ATTACHMENT A

Proposed Technical Specification Changes

Proposed Technical Specification Modifications

ATTACHMENT B

Figure 3.2-1

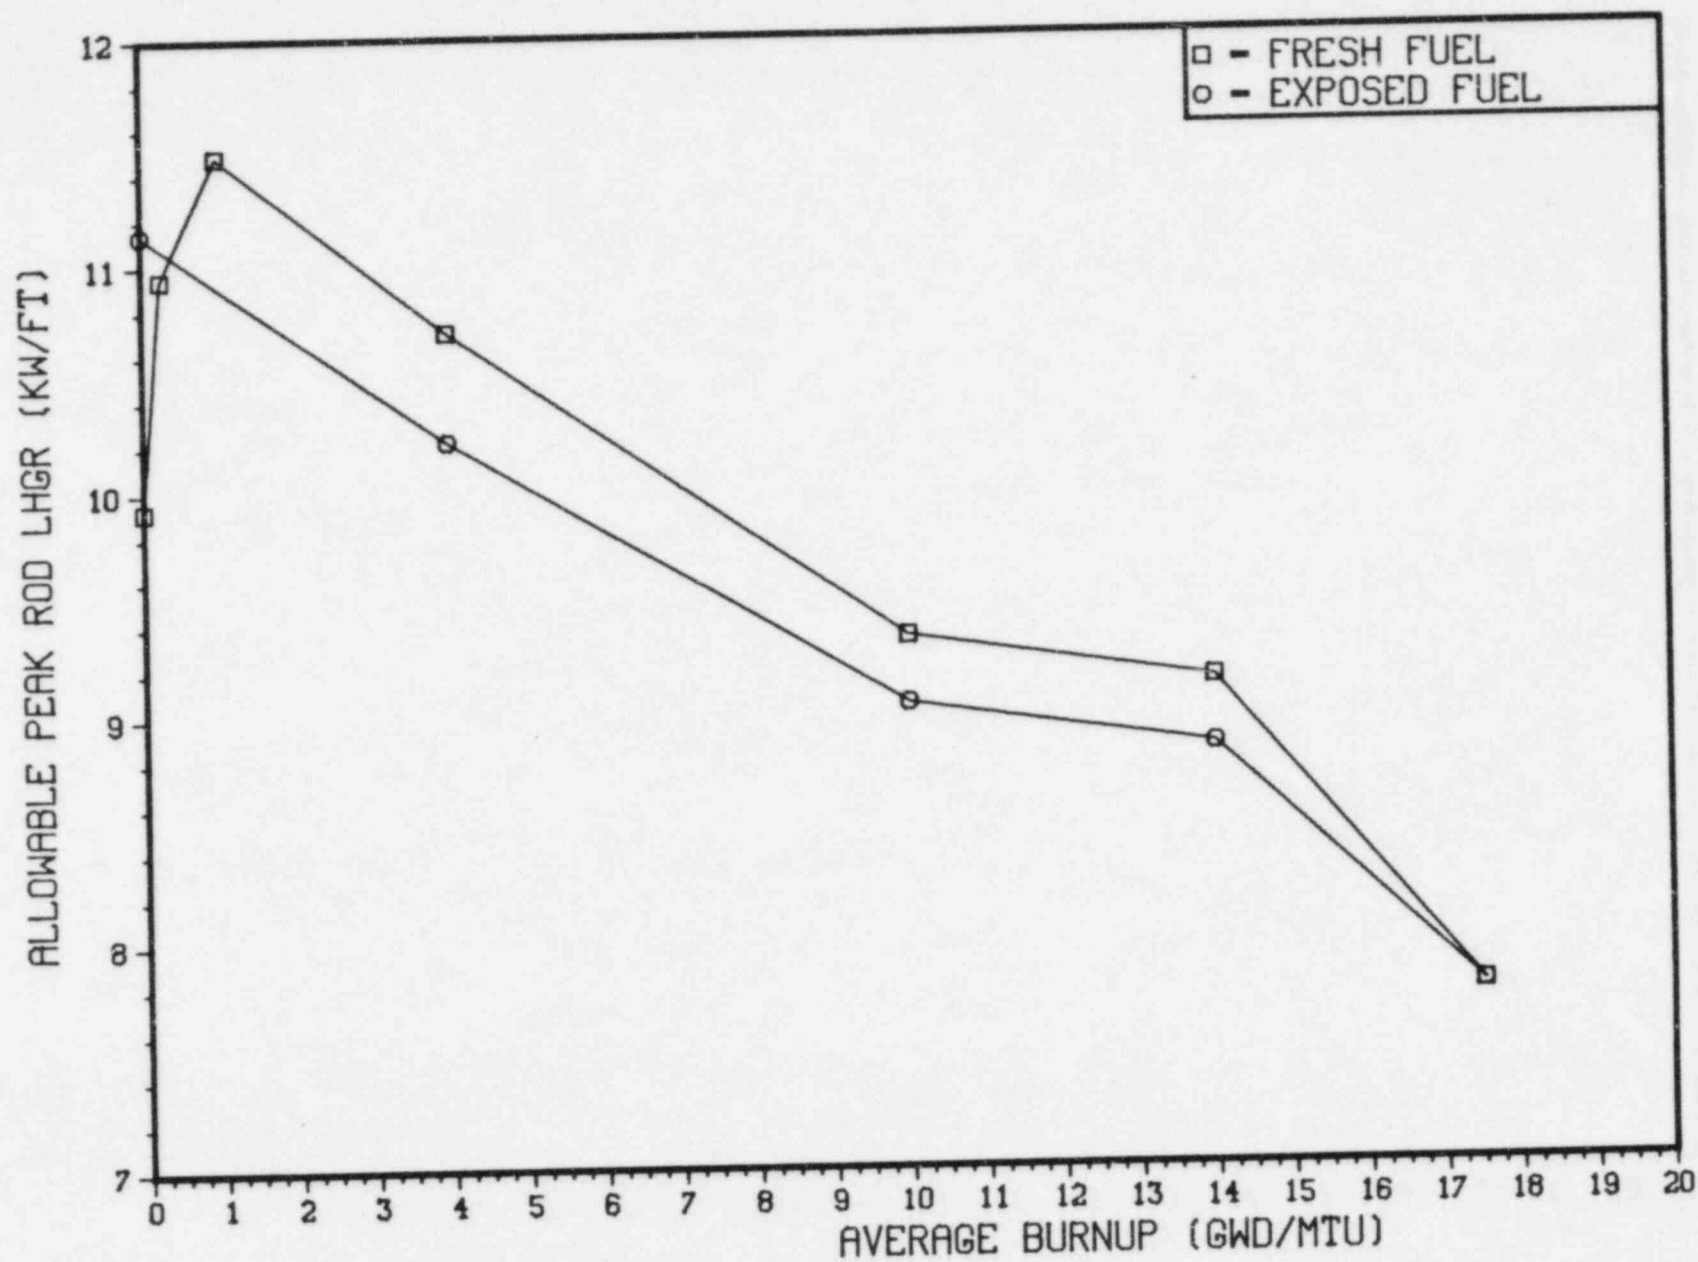
4.	Figure 3.2-1 p. 3/4 2-4	Replace current peak LHGR curve with the enclosed new curve.	LOCA limits have been recalculated as described in Section 9 of the Core XVIII Core Performance Analysis Report, Attachment B.

Figure 3.2-3
Multiplier for Xenon Redistribution as a
Function of Exposure

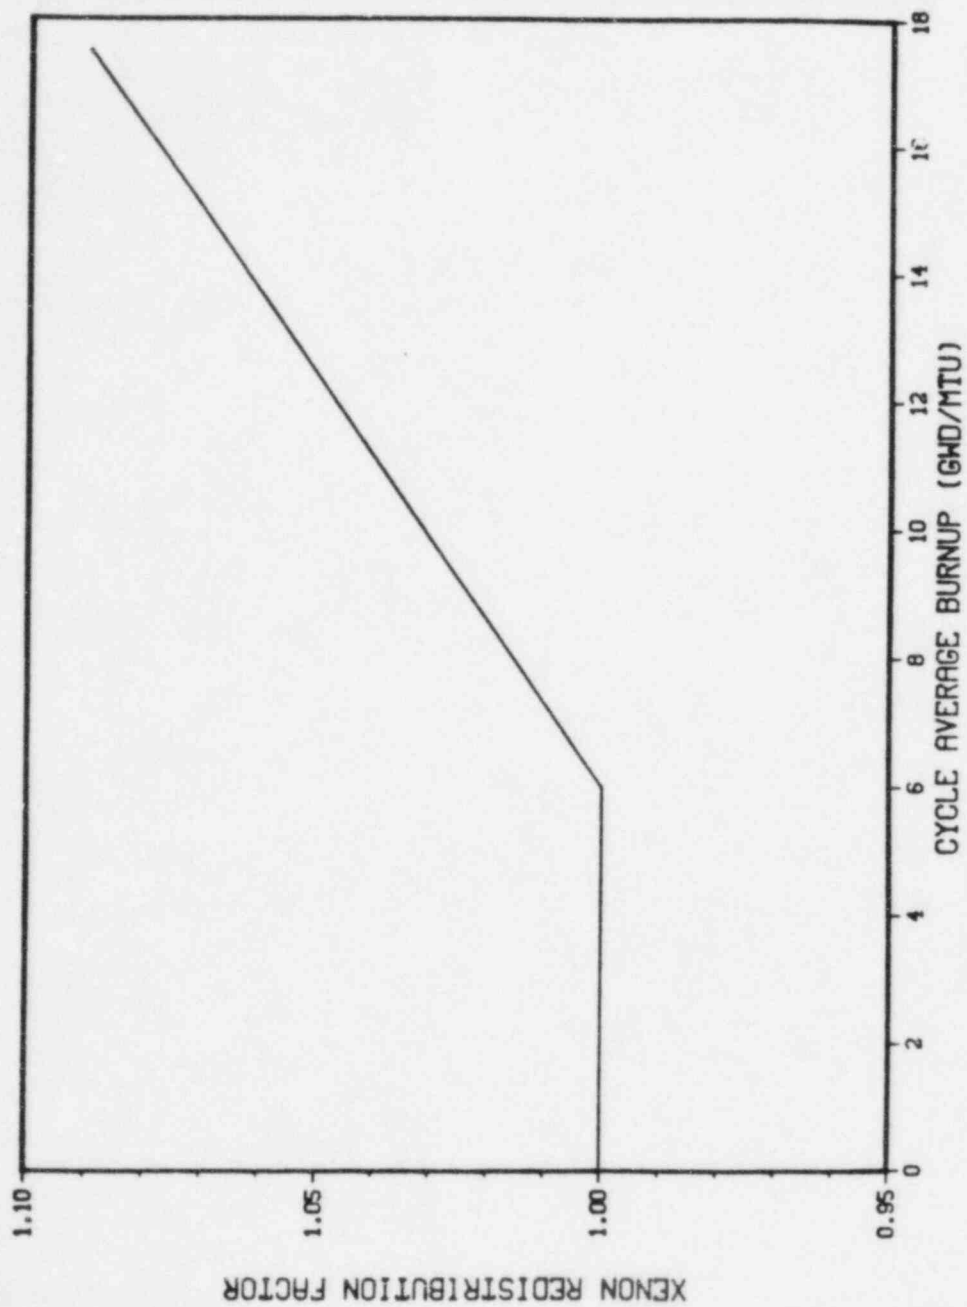
6.	Figure 3.2-3 p. 3/4 2-6	Replace current xenon redistribution curve with the enclosed new curve.	The new curve reflects the basis for establishing the worst axial power shapes for determining peak LHGR limits from the LOCA analysis, as discussed in Section 5.1 of the Core XVIII CPAR, Attachment B.

Figure 3.2-4
Multiplier for Reduced Power as a Function of Exposure

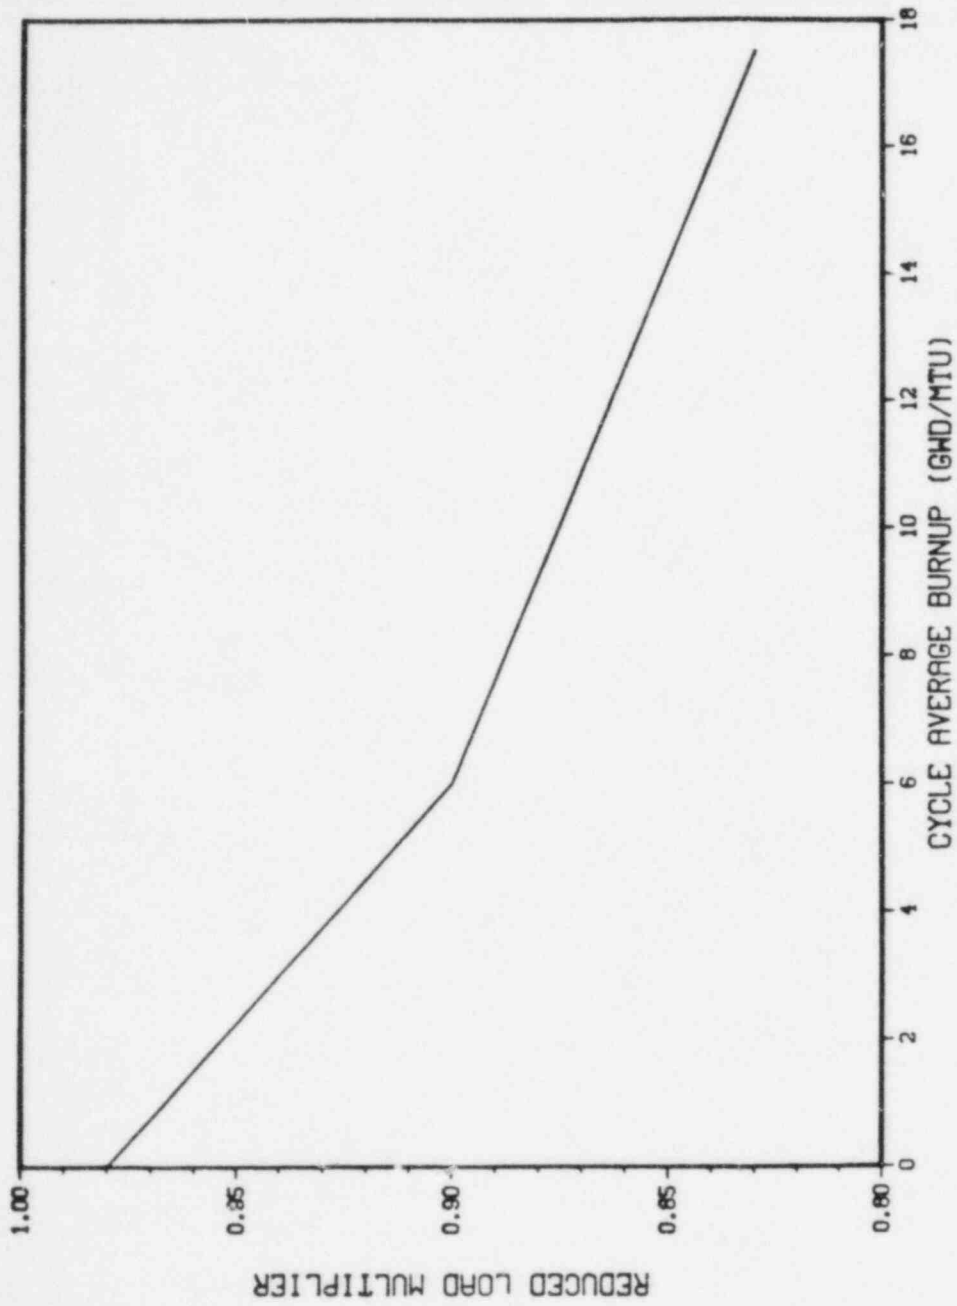
7.	Figure 3.2-4 p. 3/4 2-7	Replace current reduced load multiplier with the enclosed new curve.	The exposure range is expanded to accommodate the expected cycle length.
